PSEG Nuclear LLC

LR-N14-0009

Salem Nuclear Generating Station Unit 2  
Renewed Facility Operating License No. DPR-75  
NRC Docket No. 50-311

Subject: Response to Request for Additional Information Regarding Steam Generator  
Tube Inspection Conducted During the Fall 2012 Nineteenth Refueling Outage  
Salem Nuclear Generating Station, Unit No. 2 Docket No. 50-311  
(ML13330A585)

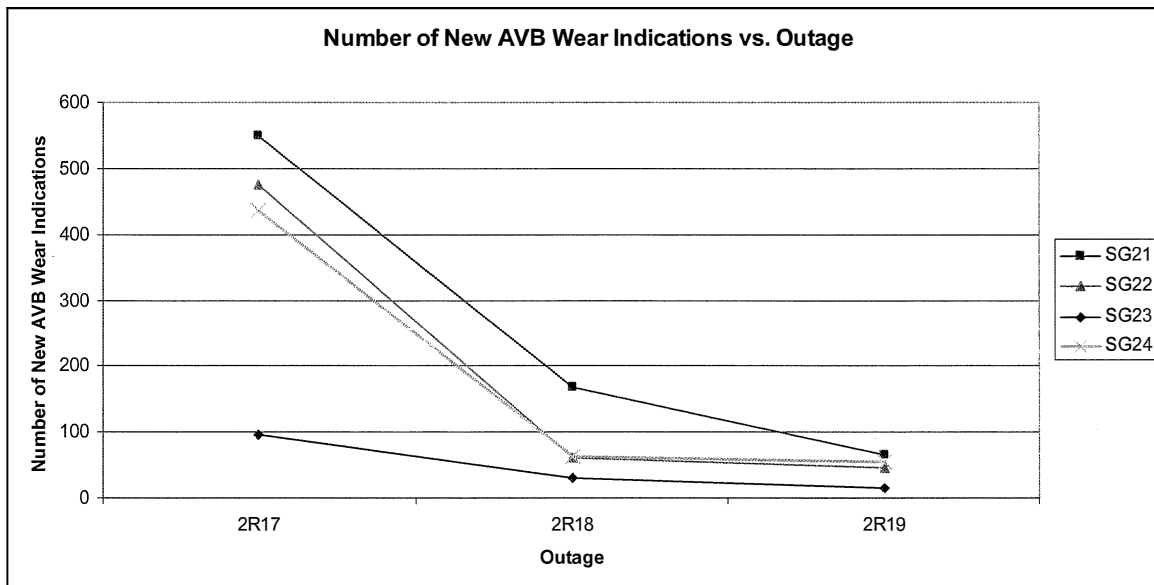
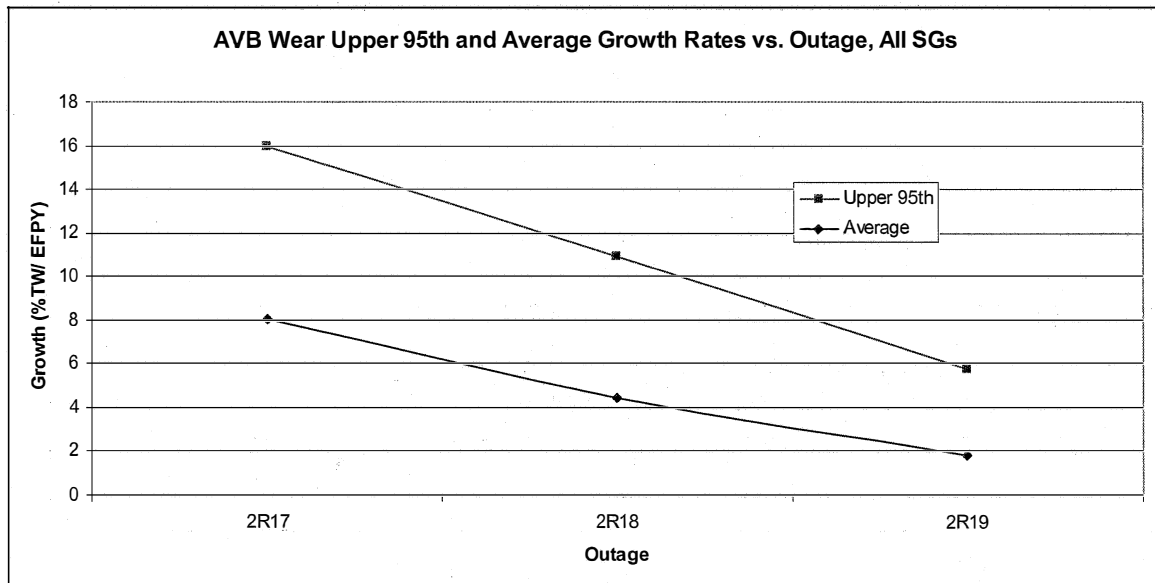
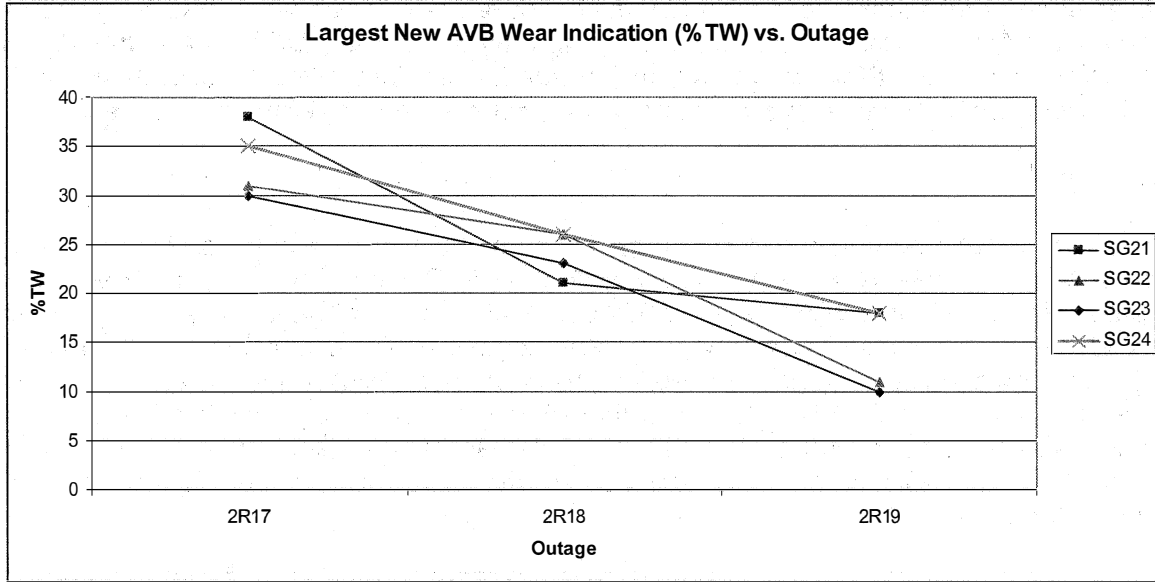
5. Please discuss whether the number of new anti-vibration bar wear indications has decreased from inspection to inspection and whether the growth rate has been decreasing with time. Please discuss any trends in this data. Please discuss whether the results of the inspection were bounded by your previous operational assessment.

Below are three graphs representing the trends for the number of new anti-vibration bar wear indications, the largest new AVB wear indication, and the AVB wear growth rates. The growth rate graph provides the trends with the upper 95<sup>th</sup> percentile growth rate and the average growth rate, for AVB wear indications with history (with exception of 2R17, since all indications in 2R17 are new). As shown in these graphs, the trends for the number of new anti-vibration bar wear indications, the largest new AVB wear indication, and the AVB wear growth rates at each inspection outage have continued to decline with each inspection outage. The findings of the 2R19 steam generator examination are bounded by the behavior projected in the cycle 19 operational assessment.
